Greater Dublin Drainage Project Addendum

Outline Construction Environmental Management Plan Addendum

Uisce Éireann

October 2023

Diagram 3.1: Updated Proposed Project Construction Programme

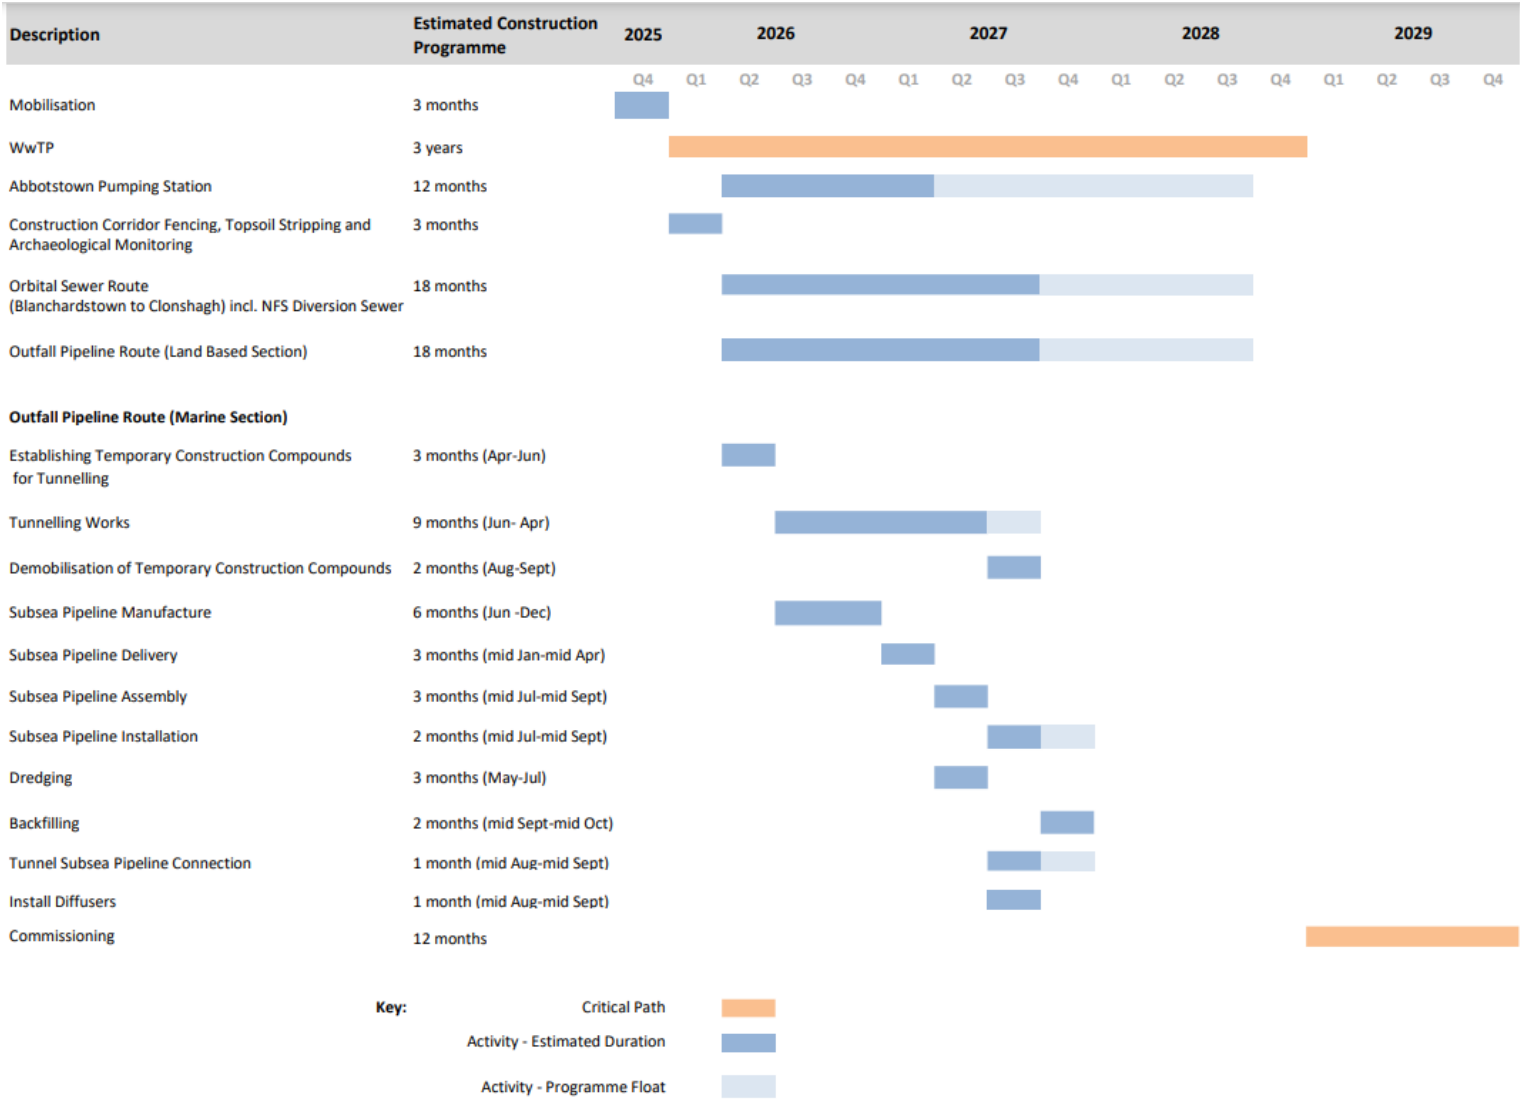
Due to the passage of time since the preparation of the original 2018 planning application, an updated estimated timeline is provided in Diagram 3.1. The total Construction Phase will remain as approximately 48 months, including 12 months of commissioning. Individual activities will have shorter durations, as shown.

Diagram 7.1: Updated Outline Construction Programme – Terrestrial Pipelines (Part of Overall Updated Programme)

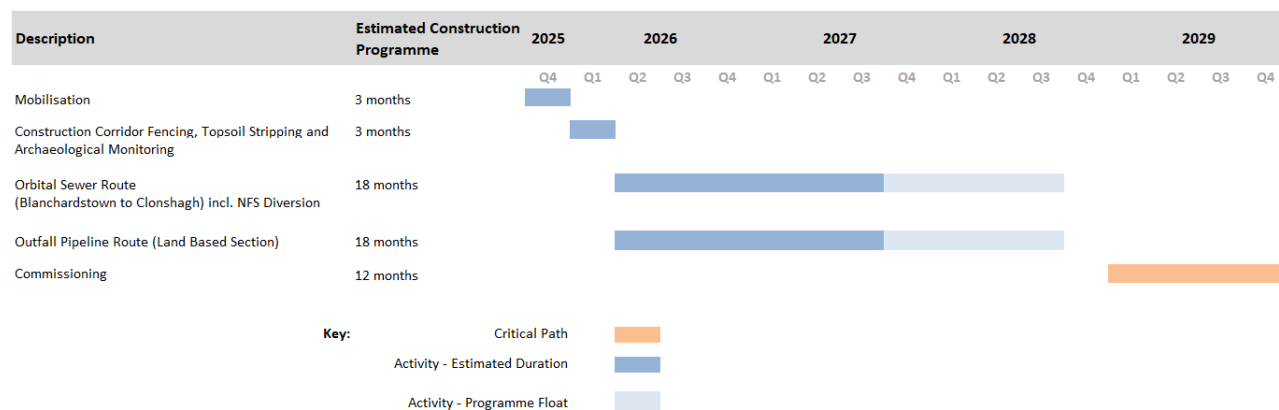
Due to the passage of time since the preparation of the original 2018 planning application, an updated estimated timeline for the terrestrial pipeline elements of the Proposed Project has been developed and is provided in Diagram 7.1. The estimated construction period for the proposed orbital sewer and outfall pipeline route (land based section) remains at 18 months. All other information provided within this Section of the of the Outline CEMP in the 2018 planning application remains valid.

Diagram 8.1: Updated Outline Construction Programme – Marine Based Pipelines (Part of Overall Updated Programme)

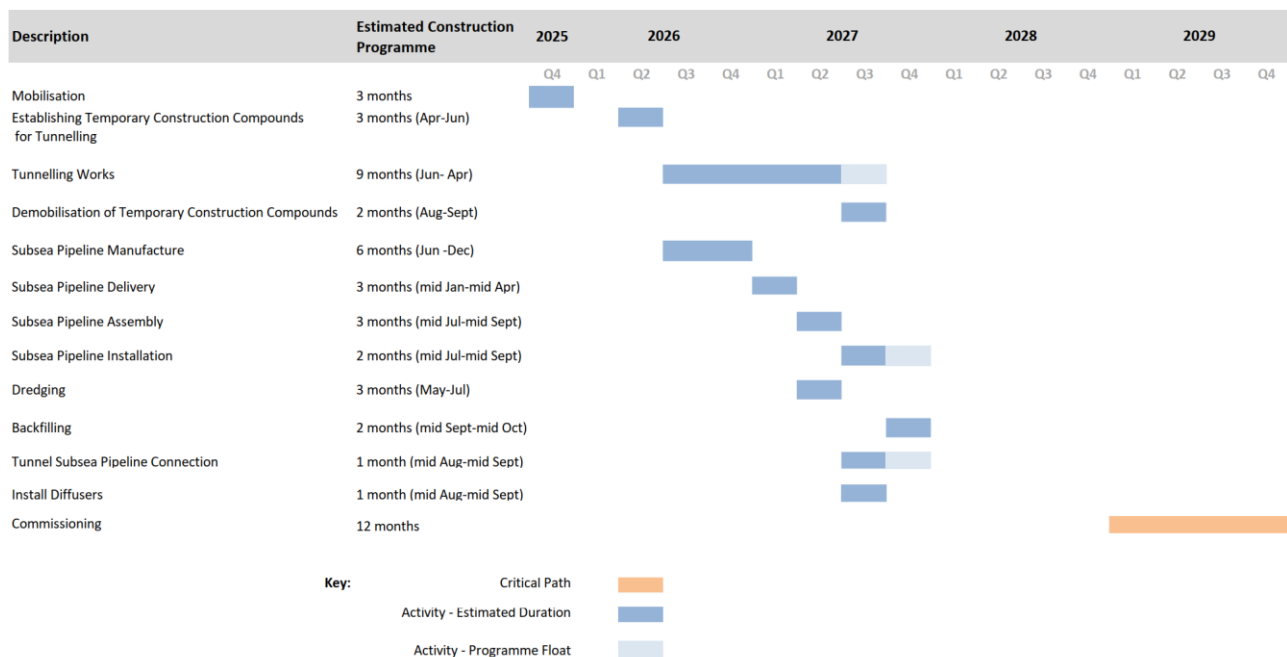
Due to the passage of time since the preparation of the original 2018 planning application, an updated estimated timeline for the marine-based pipeline elements of the Proposed Project has been developed and is provided in Diagram 8.1. The estimated construction period of the micro-tunnelled section remains at 12 months, including for site mobilisation. All other information provided within this Section of the of the Outline CEMP in the 2018 planning application remains valid.
